UNITED STATES PATENT AND TRADEMARK OFFICE

APPLICATION NO.	FILING DATE	FIRST NAMED INVENTOR	ATTORNEY DOCKET NO.	CONFIRMATION NO.
10/664,666	09/18/2003	Douglas R. Hackler SR.	51889/5	4619

Office Action Summary

Fig. 4F

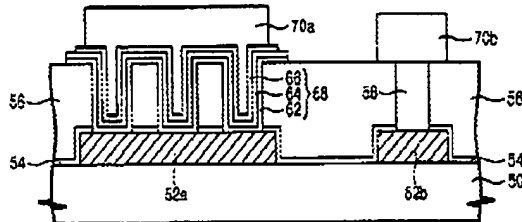
Jin et al. disclose in fig. 4f, a substrate (50), a conductive material (52a) formed above the substrate; an insulating material (54, 56) formed on the conductive material wherein the insulating material and the conductive material serve as a form for defining a plurality of capacitor trenches above the conductive layer, the insulating material defines the trench sidewalls and the conductive material defines the trench bases, a bottom electrode (62) formed onto the capacitor trenches so as to form a layer within the capacitor trenches in contact with the conductive material, wherein the bottom electrode extends up the sides of the capacitor trenches to form bottom electrode sidewalls; a capacitor dielectric (64) at least partially positioned on the bottom electrode; and a top electrode (66, 70a) at least partially positioned on the capacitor dielectric, substantially filling the capacitor trenches and forming an interconnect.

Regarding claim 11, Jin et al. disclose the bottom electrode further comprises a bottom electrode top wall (see fig. 4F).

Regarding claim 12, Jin et al. disclose the bottom electrode further comprises a bottom electrode base (see fig. 4F).

FIG.19

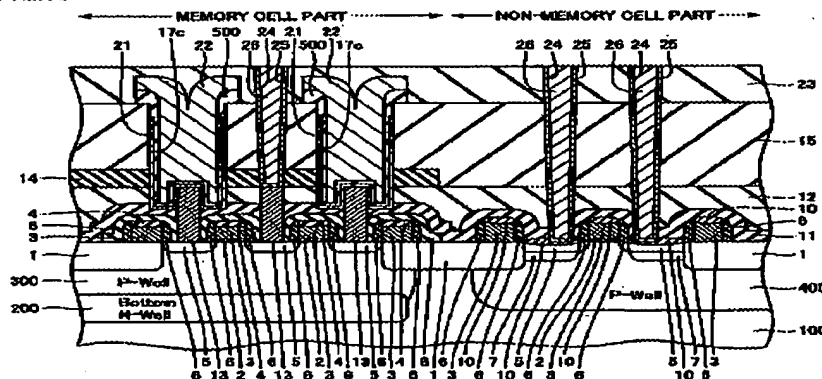
Kubo discloses in fig. 19, a capacitor structure comprising: a substrate (100), an insulating material (12, 14, 15) formed on the substrate, wherein the insulating material serves as a form for defining a capacitor trench; a bottom electrode (21), wherein the bottom electrode comprises a bottom electrode layer in the capacitor trench and a bottom electrode plug (13) disposed in the capacitor trench, wherein the bottom electrode layer extends up the sides of the capacitor trench to form bottom electrode sidewalls; a capacitor dielectric (500) at least partially position on the bottom electrode and at least partially formed on the bottom electrode plug; a top electrode (22) at least partially position on the capacitor dielectric and at least partially formed around the bottom electrode plug.

Regarding claim 35, Kubo discloses the bottom electrode and the capacitor dielectric are formed in the shape of a box (abstract and fig. 19).

Regarding claim 36, Kubo discloses the top electrode is at least partially disposed in the capacitor trench such that the top electrode interdigitates the bottom electrode (see fig 19).

Regarding claim 37, Kubo discloses the bottom electrode further comprises a bottom electrode top wall (see fig. 19).

Regarding claim 38, Kubo discloses the bottom electrode further comprises a bottom electrode base (see fig. 19).

1) The plug and bottom electrode layer (as combined) form a "bottom electrode layer", wherein the bottom electrode plug is disposed within the capacitor trench, and a dielectric at least partially formed on the bottom electrode. The plug extends into the capacitor trench as seen in fig. 19.

Fig. 4f

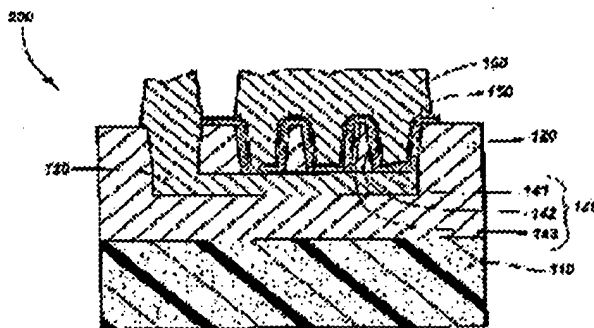
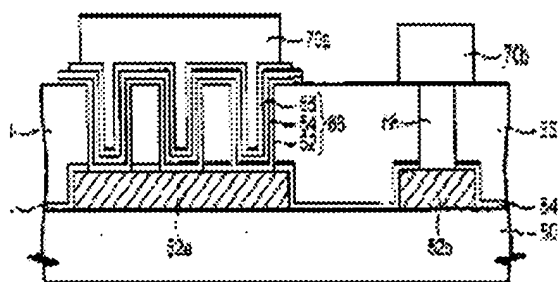
2) Jin discloses the top electrode (66, 70a) "substantially fills" the trench (see below & element of 160 of present invention).
